Access Compliance Report

Public Rights-of-Way

(Curb Ramps)

Intersection ID: 46345	Main Street: BENNETT_NEELY_LN	Cross Street: MINT_THISTLE_CT	Location:	N
ADA ID: 139398EEBEFE	Ramp Type: BlendTrans1	Initial Pass/Fail: Fail	Overall Compliance: No	Severity Score: 8.75

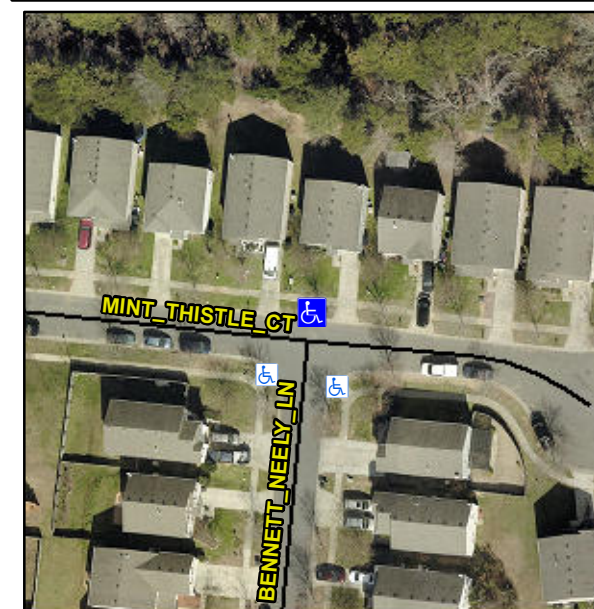
LNDG LIP 1.0

Not Found, R304.5.1

Remove & Replace Curb Ramp With Two New Directional Ramps or Equivalent.
